Addendum #1

Project Name: Indiana State University – Dreiser Hall Renovation

Project #: 19052

Date: June 12, 2020

1 Floor Plan
First Floor Plan
A1.01 1/8" = 1'-0"

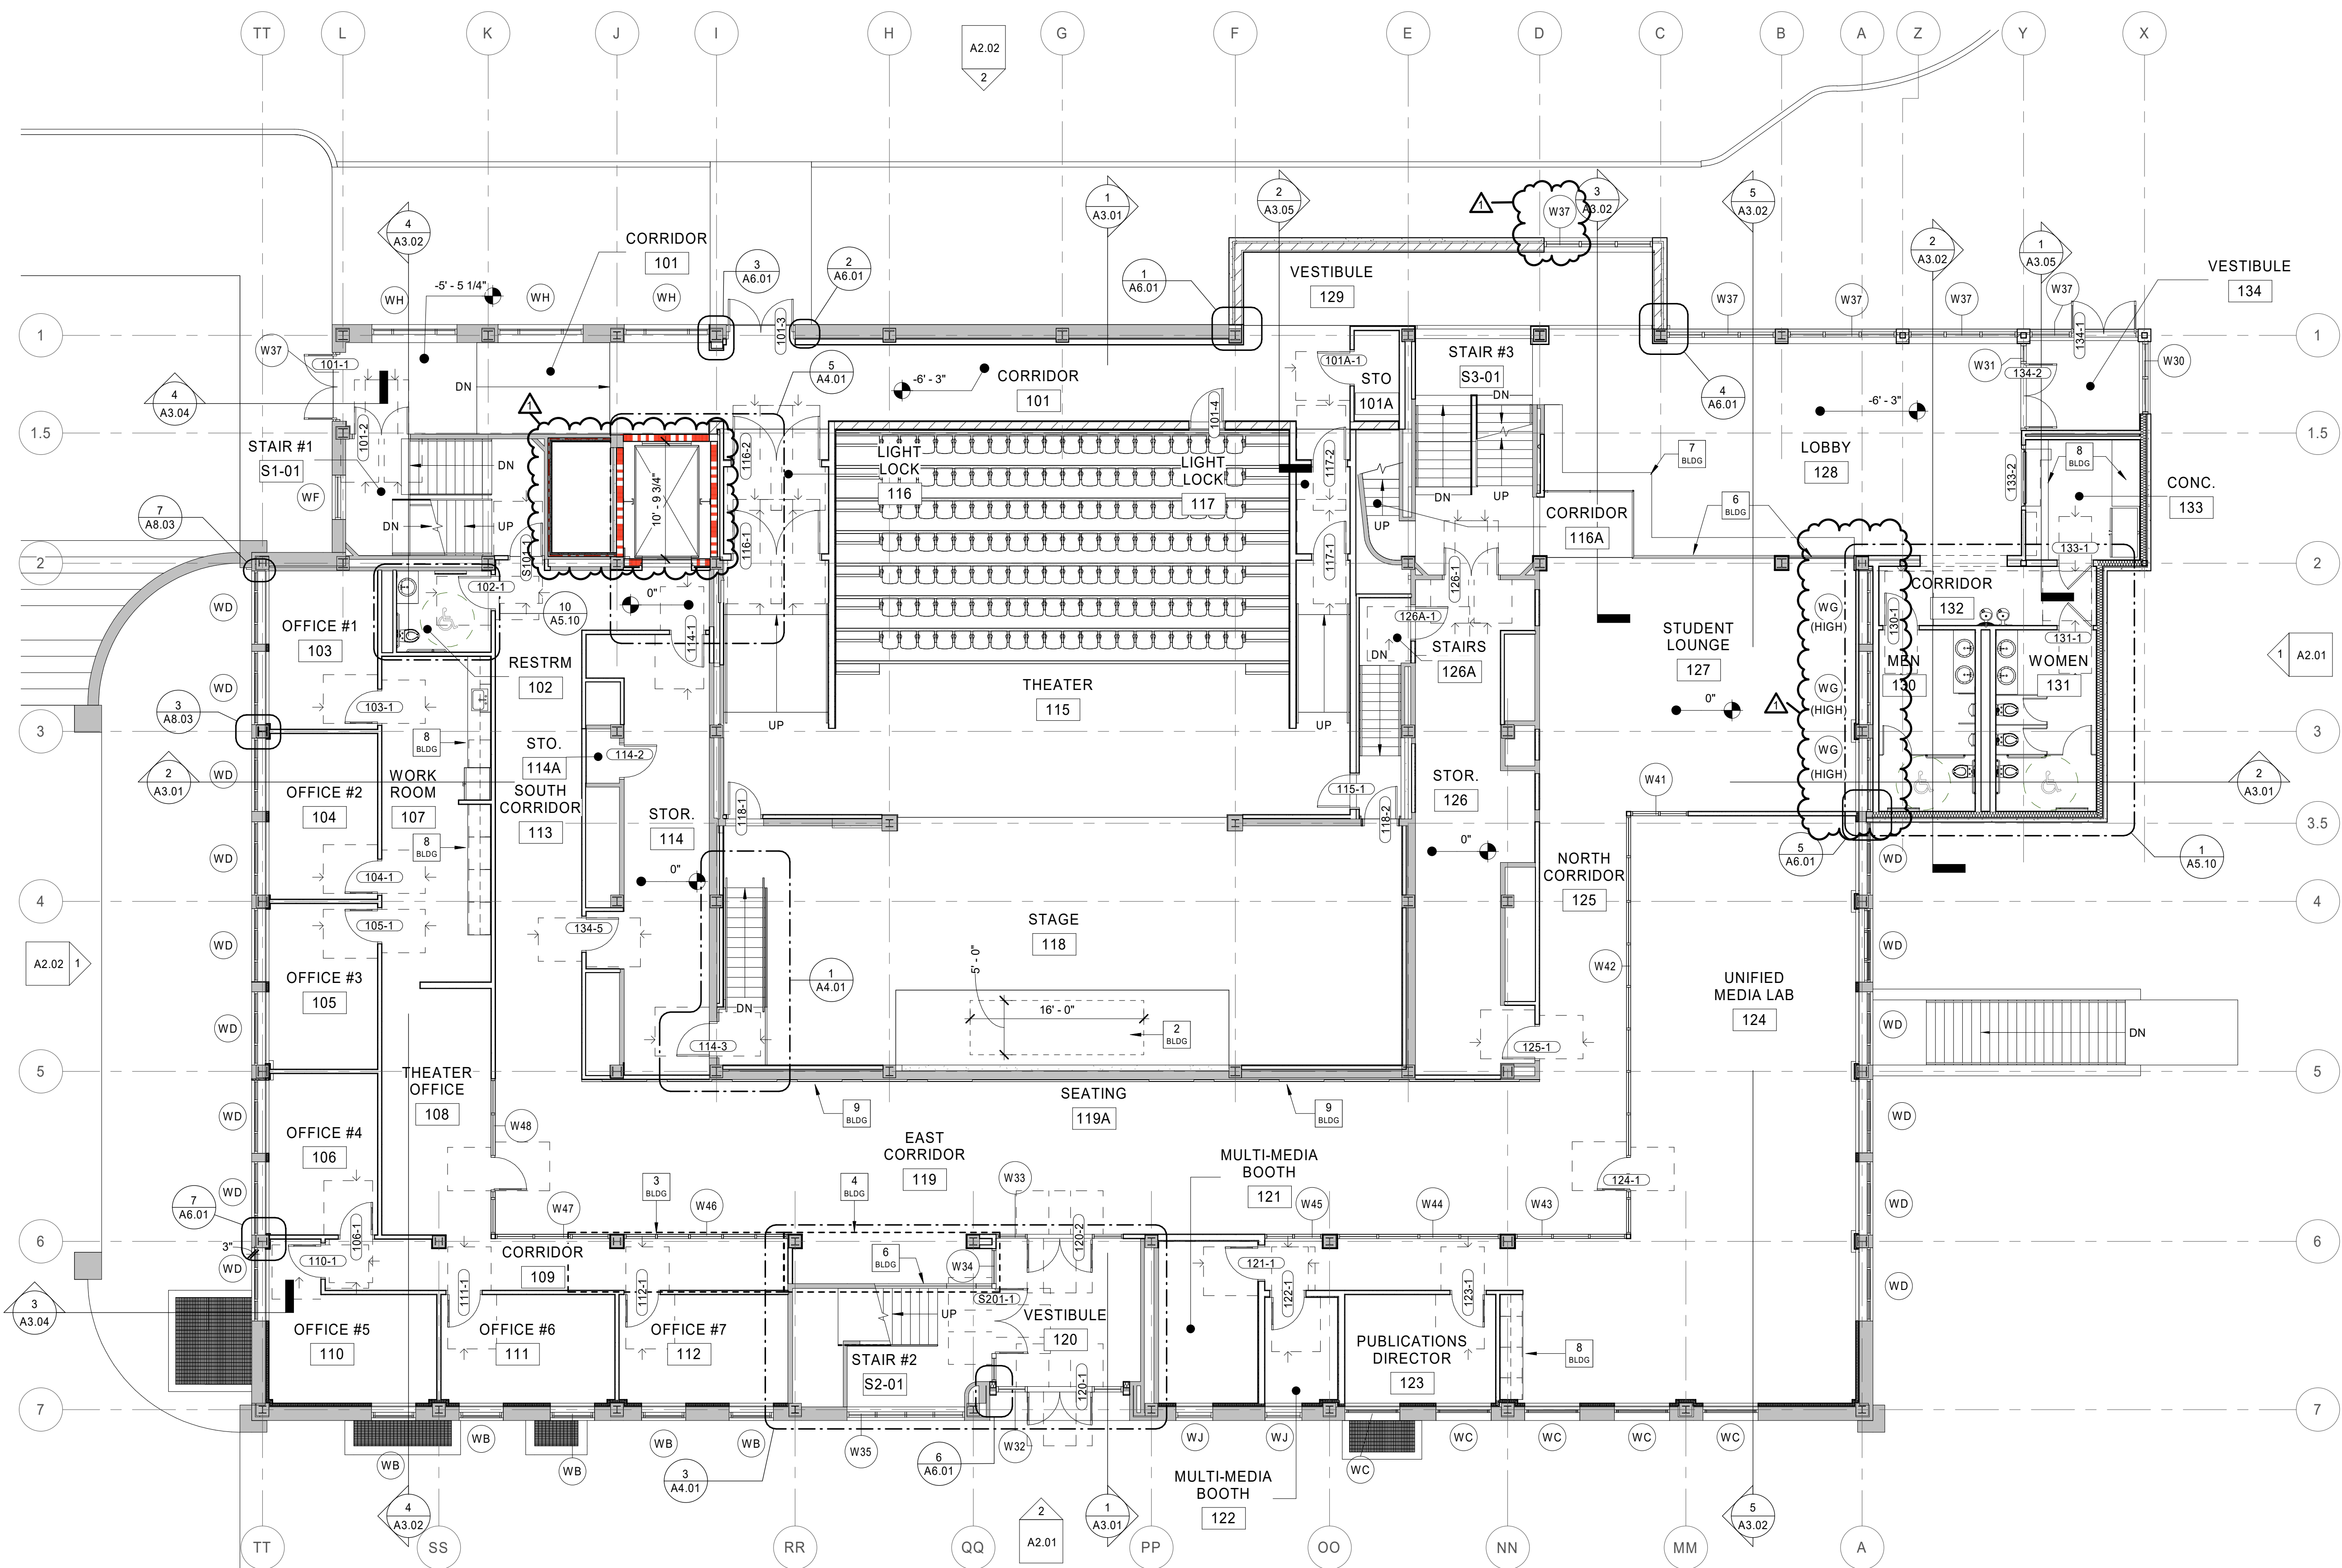
- A. Reissue sheet – see clouds
B. Add rated wall indicators.
10. Sheet A1.01A – First Dimension Plan
- A. Reissue sheet – see clouds
B. Update wall tags.
11. Sheet A1.00C – First Floor Finish Plan

1 Floor Plan
2nd Floor Plan
A1.02 1/8" = 1'-0"

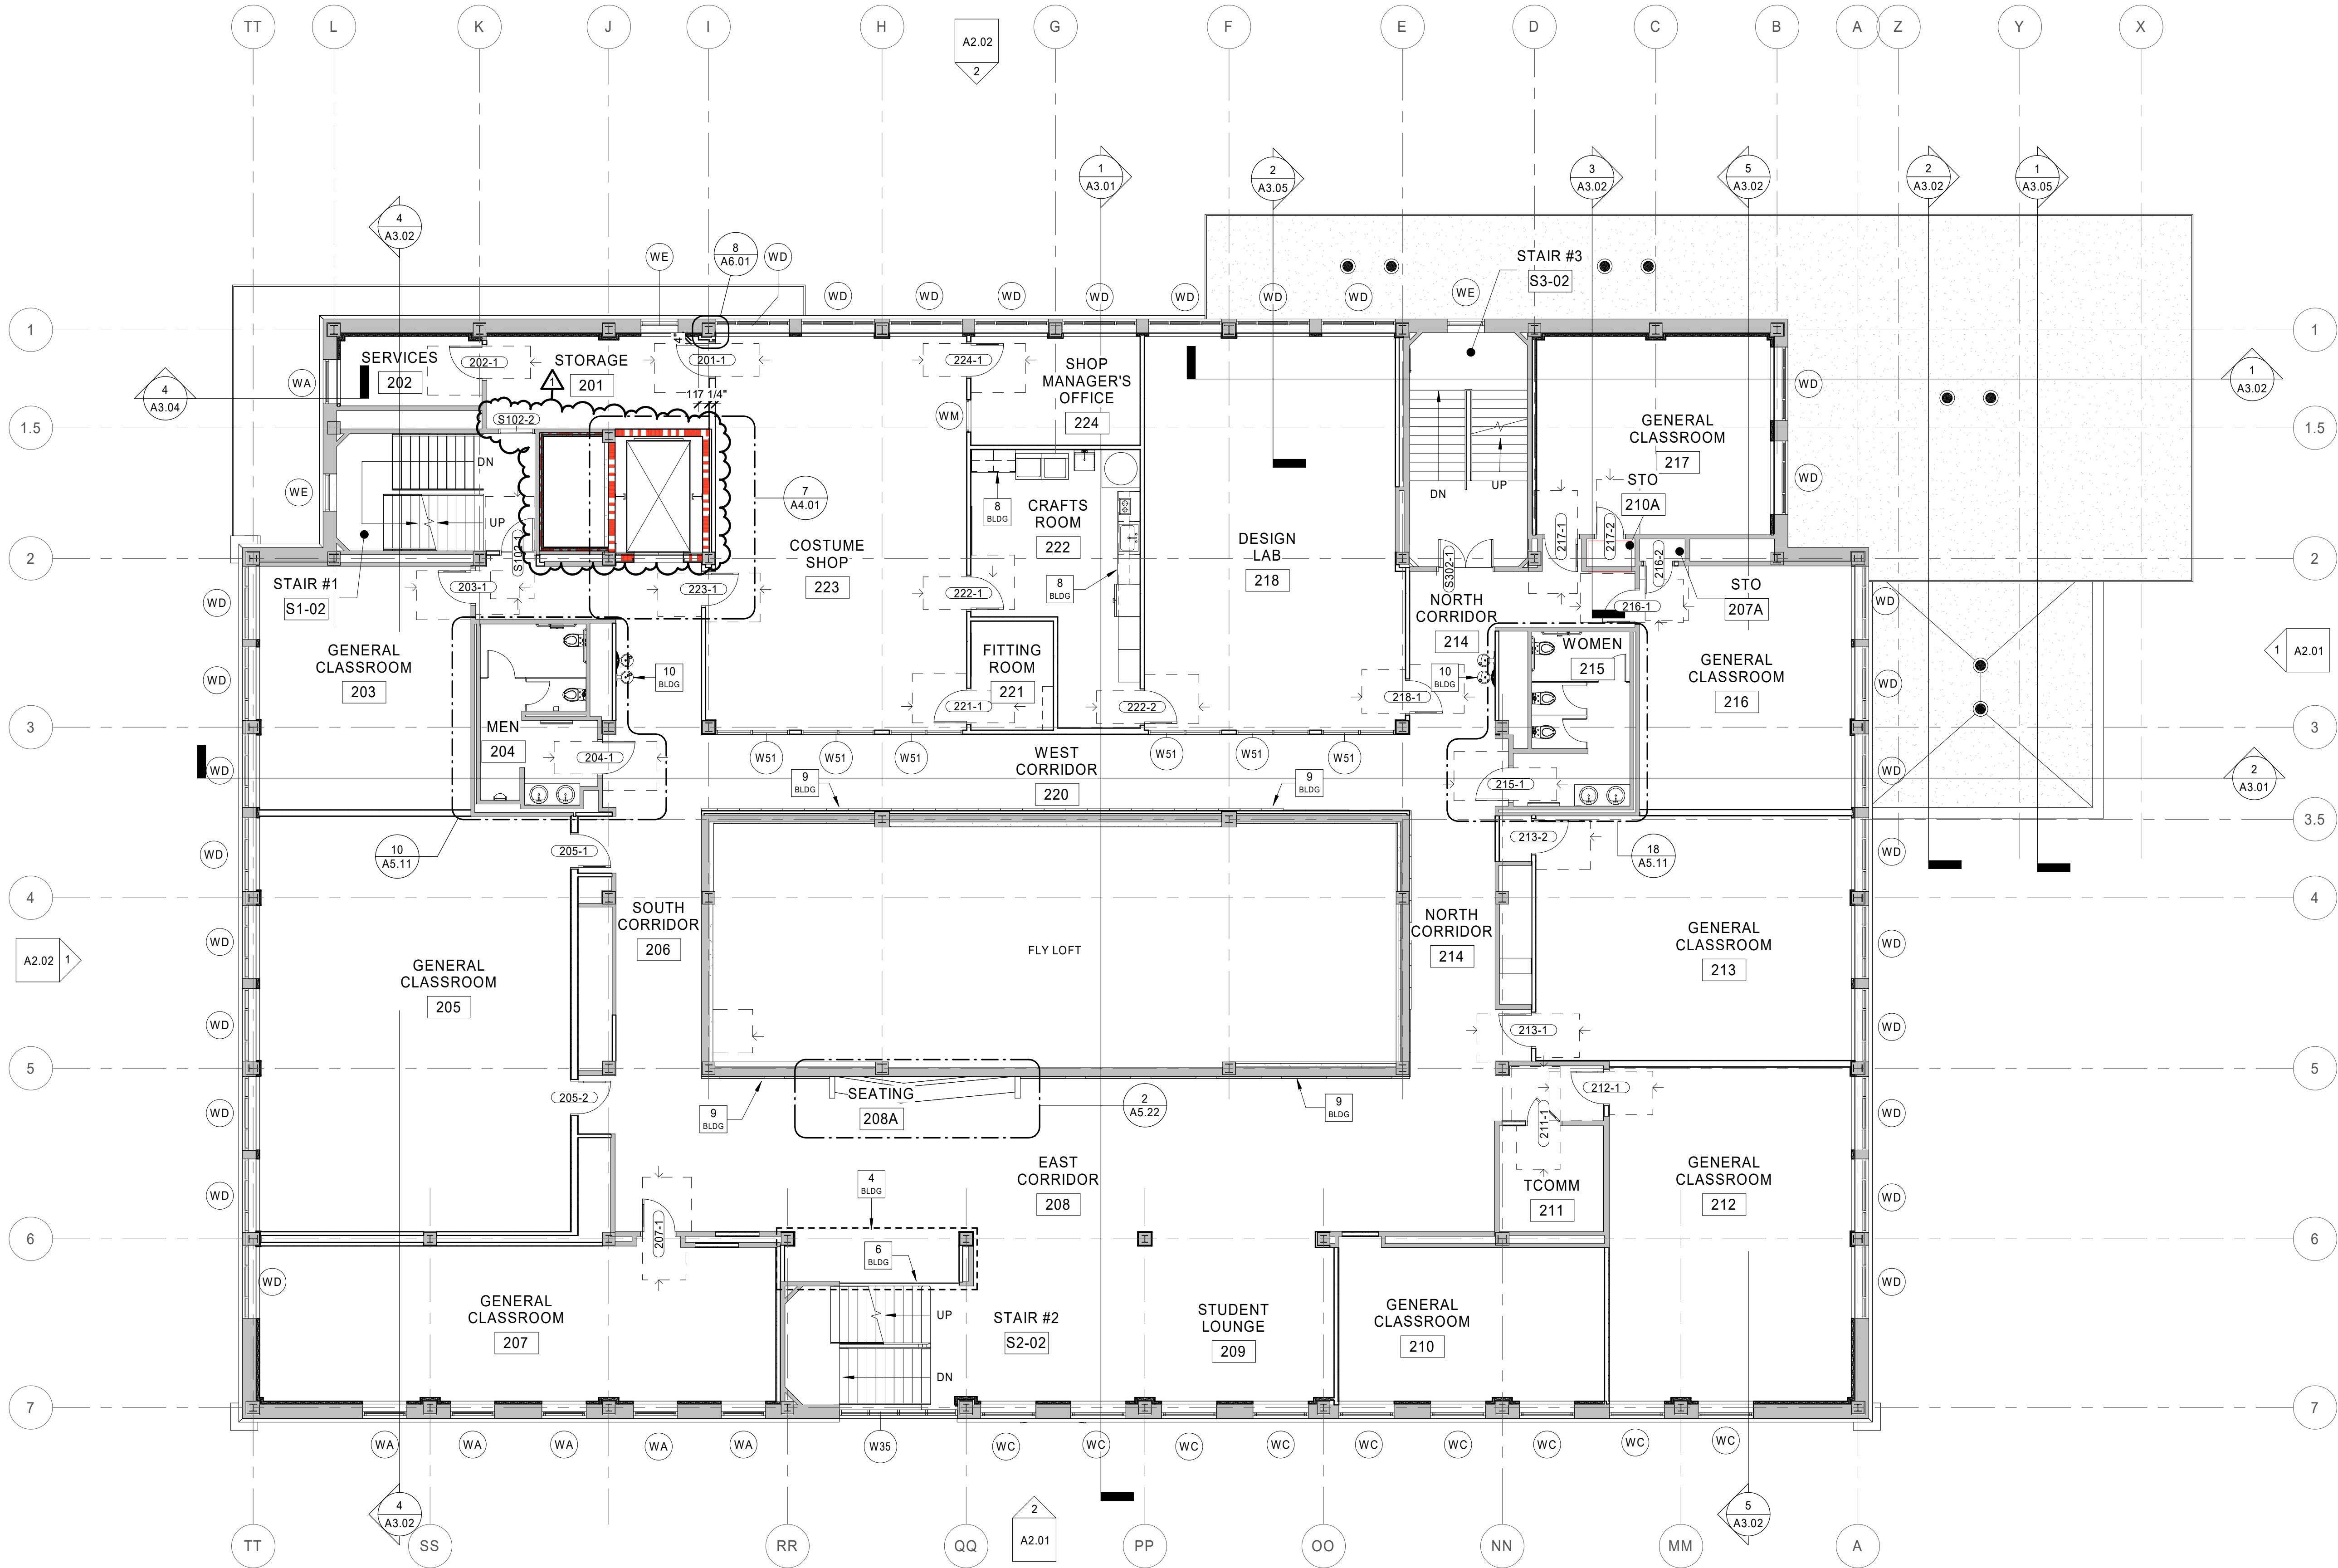
- A. Reissue sheet – see clouds
12. Sheet A1.02 – Second Floor Plan
- A. Reissue sheet – see clouds
B. Add rated wall indicators.
13. Sheet A1.02A – Second Dimension Plan

1 Floor Plan
2nd Floor - Dimension Plan
A1.02A 1/8" = 1'-0"

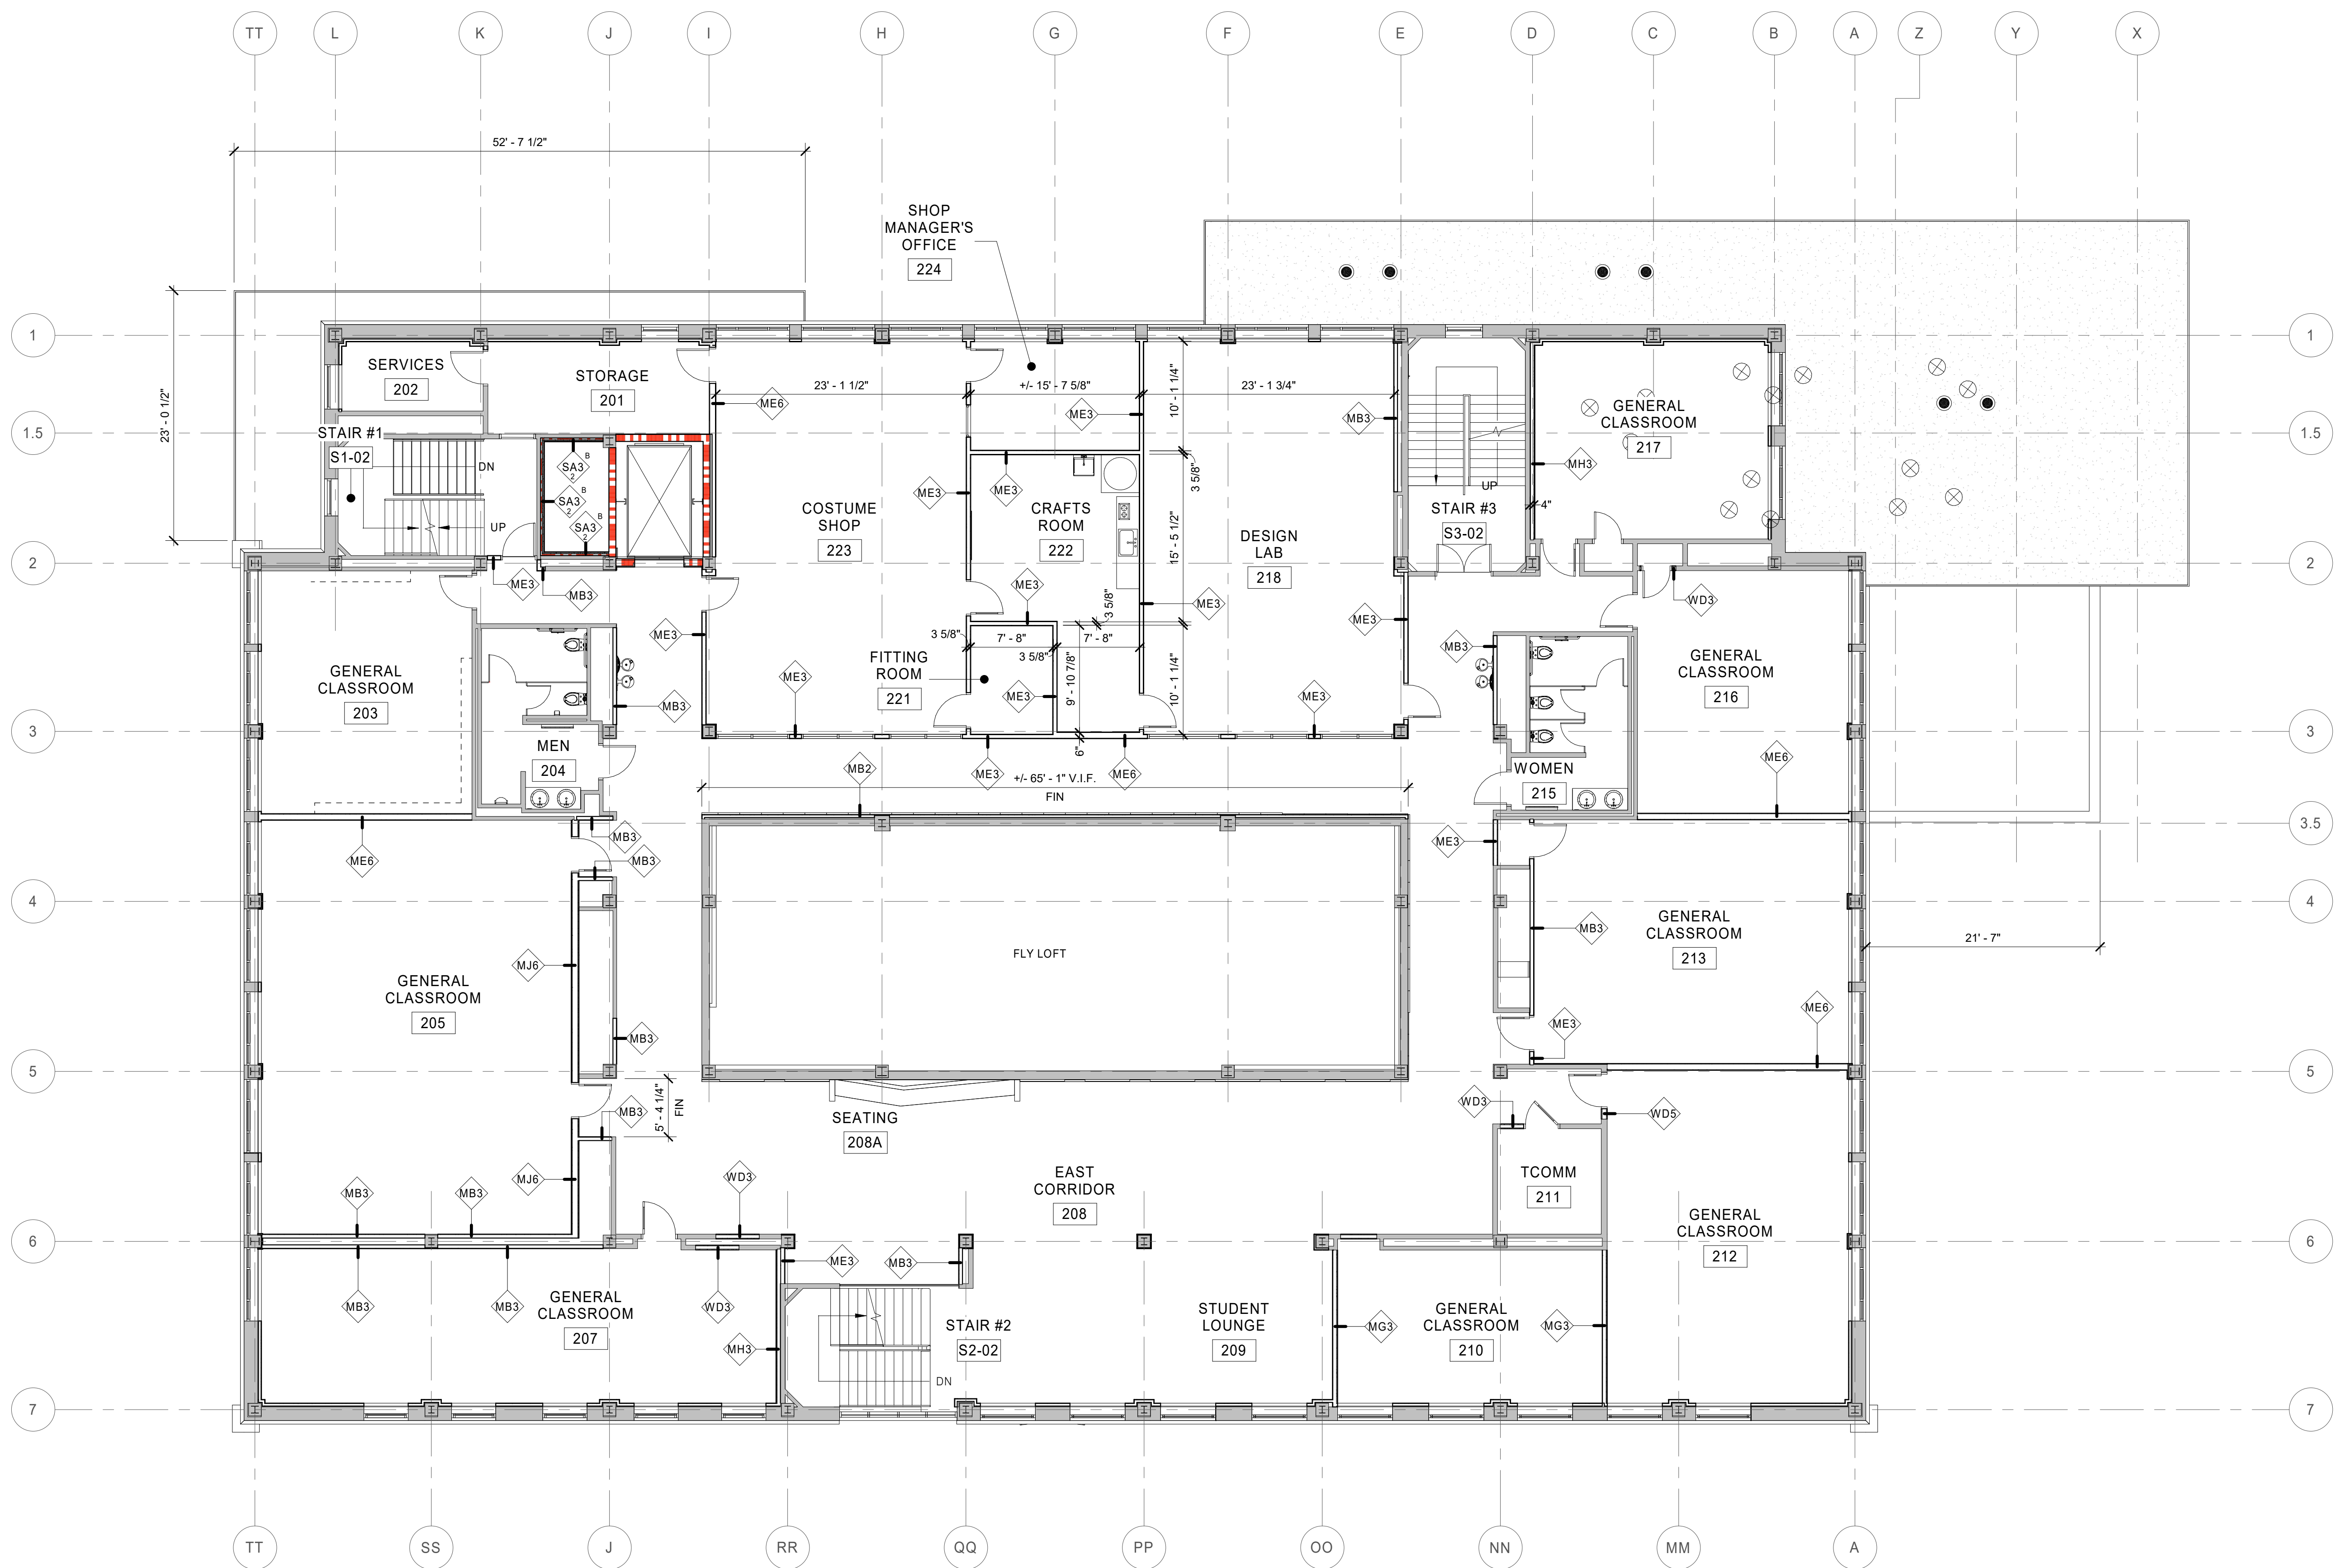
- A. Reissue sheet – see clouds
B. Update wall tags.
14. A1.02C 2nd Floor Finish Plan
- A. Reissue sheet – see clouds
15. A1.02E 2nd Floor Furniture Plan
- A. Reissue sheet – see clouds
